## **Proposal for amendments to ECE/TRANS/WP.29/GRSP/2014/23**

The modifications to the draft new Regulation (ECE/TRANS/WP.29/GRSP/2014/10) are marked in bold for new or strikethrough for deleted characters. The modifications to ECE/TRANS/WP.29/GRSP/2014/23 are highlighted in yellow. **The modifications decided during this GRSP are highlighted in green.**

Model A

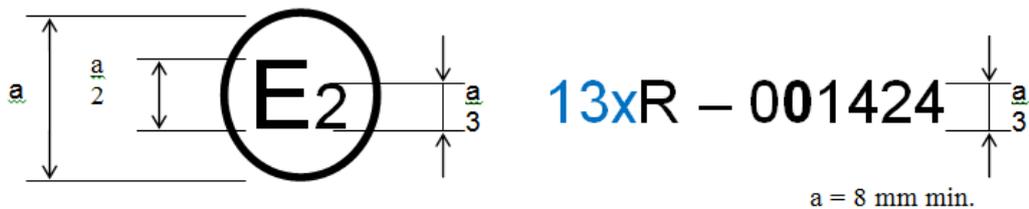
The above approval mark affixed to a vehicle shows that the vehicle type concerned has, with regard to the protection of the occupants in the event of a frontal collision, been approved in ~~the Netherlands (E 4)~~ France (E 2) pursuant to Regulation No. 13x [X] under approval number 001424. The approval number indicates that the approval was granted in accordance with the requirements of Regulation No. 13x [X] as amended by the 020 series of amendments.

Figure 1

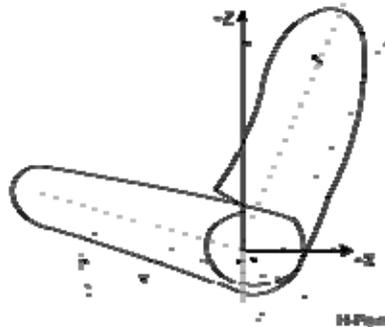
The longitudinal and vertical dimension of "H" point are described as ( $X_{50thM}$ ,  $Z_{50thM}$ ) and the longitudinal and vertical dimension of "H 5<sup>th</sup>" point are described as ( $X_{5thF}$ ,  $Z_{5thF}$ ). XSCL is defined as the horizontal distance between the "H" point and the most forward point on the seat cushion (see Fig. 1). Use the following formula to calculate the "H 5<sup>th</sup>" point. Note that  $X_{5thF}$  should always be more forward than the  $X_{50thM}$ .

$$X_{5thF} = X_{50thM} + (93\text{mm} - 0.323 \times XSCL)$$

$$Z_{5thF} = Z_{50thM}$$

**Figure 2**  
**The initial knee distance of Hybrid III 5th percentile female**

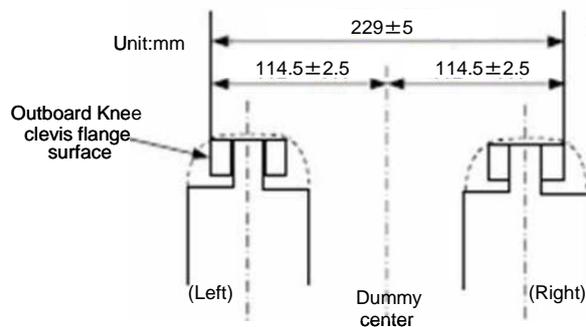
The upper legs of the passenger test dummy shall rest against the seat cushion to the extent permitted by placement of the feet. The initial distance between the outboard knee clevis flange surfaces shall be ~~270 mm ± 10 mm~~ **229 mm ± 5 mm** as shown in Figure 2. To the extent practicable, both legs of the passenger dummy shall be in vertical longitudinal planes. Final adjustment to accommodate placement of feet in accordance with paragraph 3.6. for various passenger compartment configurations is permitted.

Fig.(a)

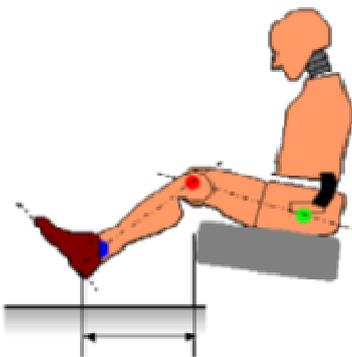
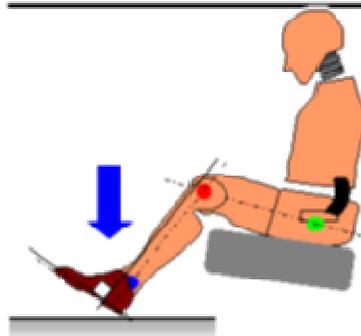
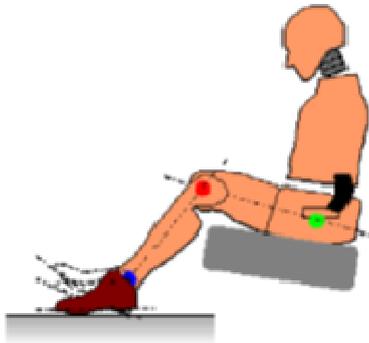
The legs shall be positioned as distant as possible from the front end of the rear seat cushion while the thighs are kept in contact with the seat cushion as shown in Fig.(a). As shown in Fig.(b), each leg shall be lowered until the foot comes in contact with the floor while the foot and tibia are kept in a right angle to one another and the thigh inclination angle kept constant. When each heel is in contact with the floor, the foot shall be rotated so that the toe comes as much in contact as possible with the floor as shown in Fig.(c).

If it is not possible to have each foot in contact with the floor, the foot shall be lowered until the calf comes in contact with the front end of the seat cushion or the back of the foot comes in contact with the vehicle interior. The foot shall be kept as parallel as possible to the floor as shown in Fig.(d).
